# TECHNICAL SERVICE BULLETIN

## *Replacing the High Temperature Cutout on Built-in Wall Ovens (Service Kit 617877)*

Mounting HTC to plenum

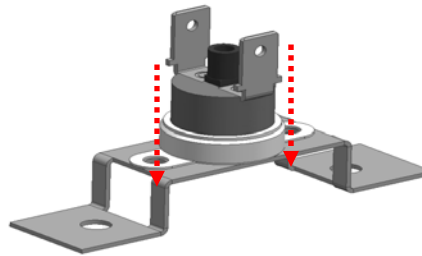
In some double 27" built-in wall ovens produced prior to March 2009, the lower oven high temperature cutout (HTC) may trip prematurely. The transfer of excessive heat to the cutout from the screws which fasten the HTC to the plenum (or to the HTC mounting bracket) has been identified as the cause. If this occurs, replace the lower oven HTC and mounting screws with the new HTC and screws included in this service kit.

**TO ENSURE PROPER OPERATION, ALL PARTS IN THIS KIT MUST BE INSTALLED.**
